**1. Core Damage Ratio of Unit 1 of Fukushima Daiichi Nuclear Power**

Reference 2

Figure 1-1 Behavior of the  $\gamma$ -ray dose rate in dry well area of Unit 1

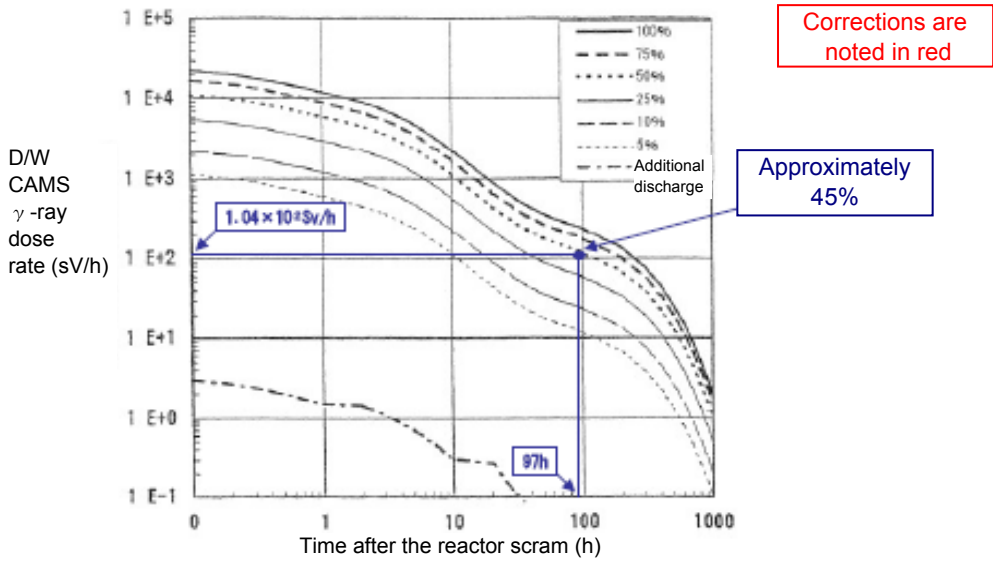
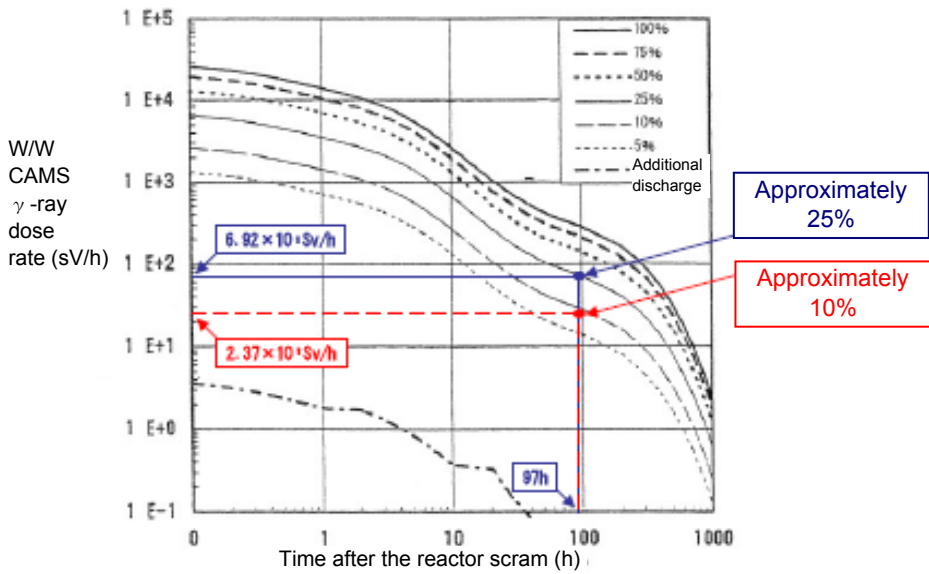
Before Correction: Approx. 45% + Approx. 25% = Approx. 70%  
 After Correction : Approx. 45% + **Approx. 10%** = **Approx. 55%**

Figure 2-1 Behavior of the  $\gamma$ -ray dose rate in dry well area of Unit 2

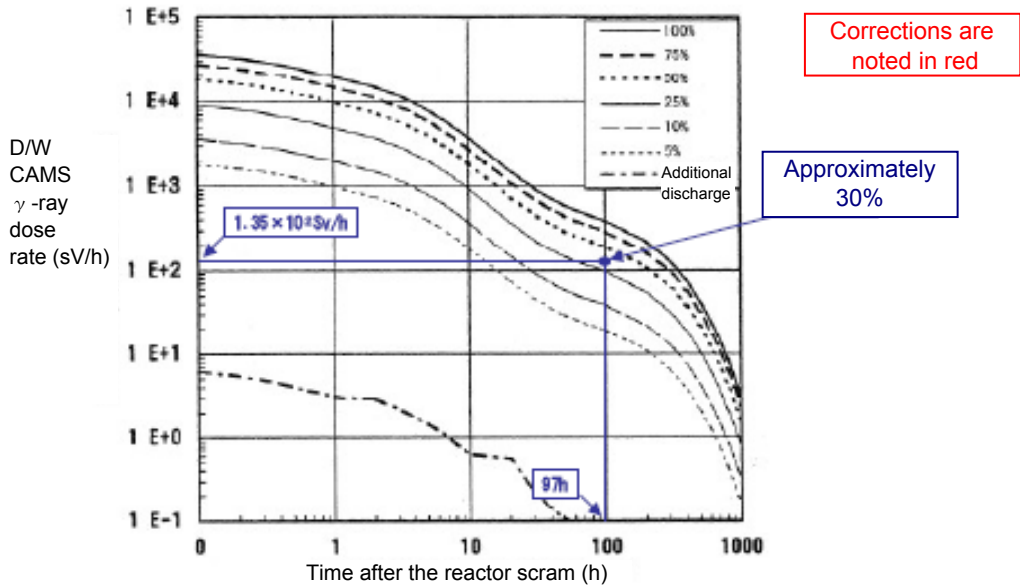
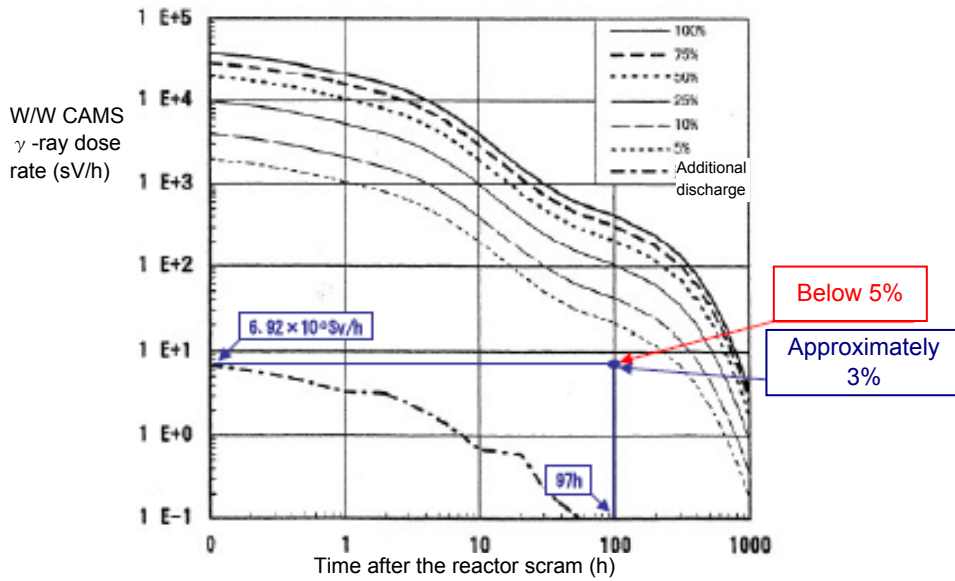
Before Correction: Approx. 30% + Approx. 3%  $\doteq$  Approx. 30%  
 After Correction : Approx. 35% + Below 5%  $\doteq$  **Approx. 35%**

Figure 3-1 Behavior of the  $\gamma$ -ray dose rate in dry well area of Unit 3

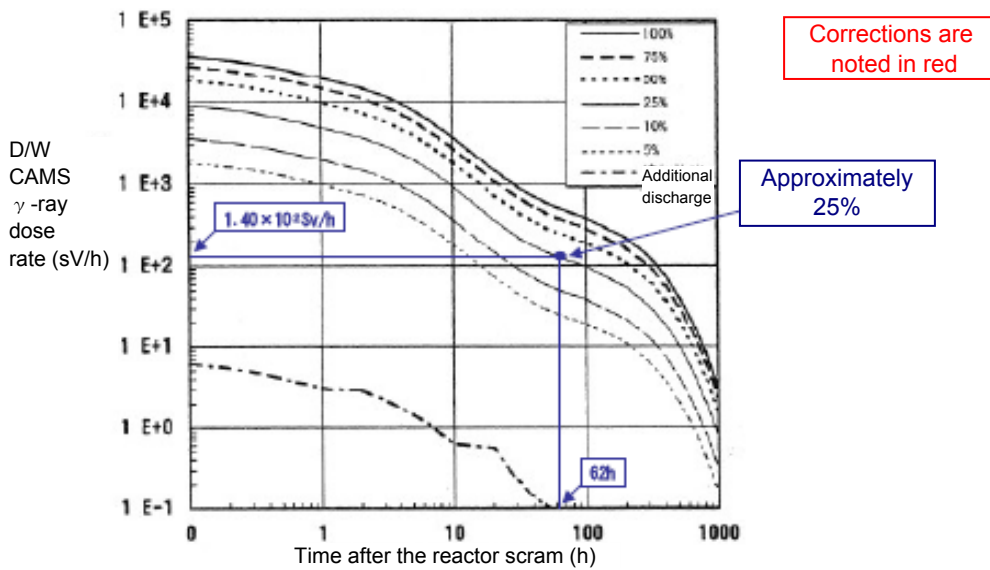
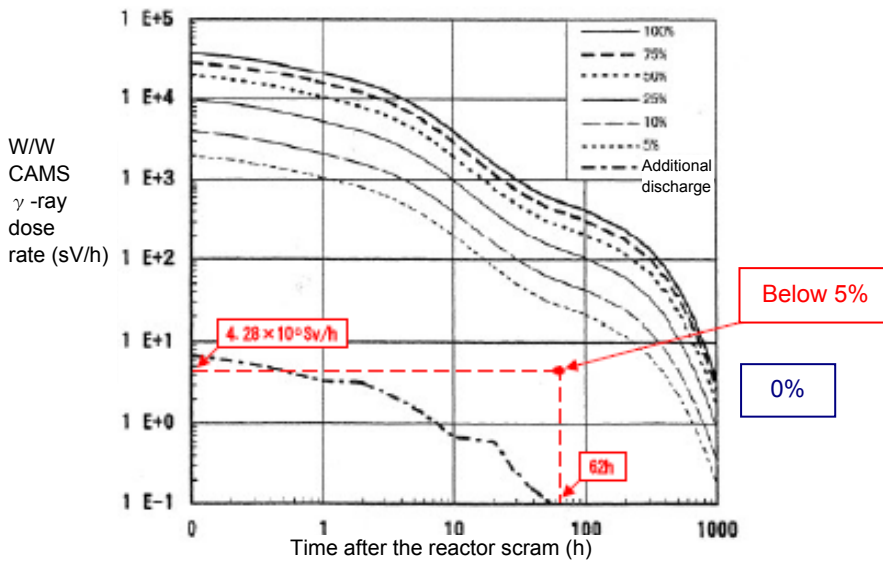
Before Correction: Approx. 25% + 0%  $\doteq$  Approx. 25%  
 After Correction : Approx. 25% + Below 5%  $\doteq$  Approx. 30%
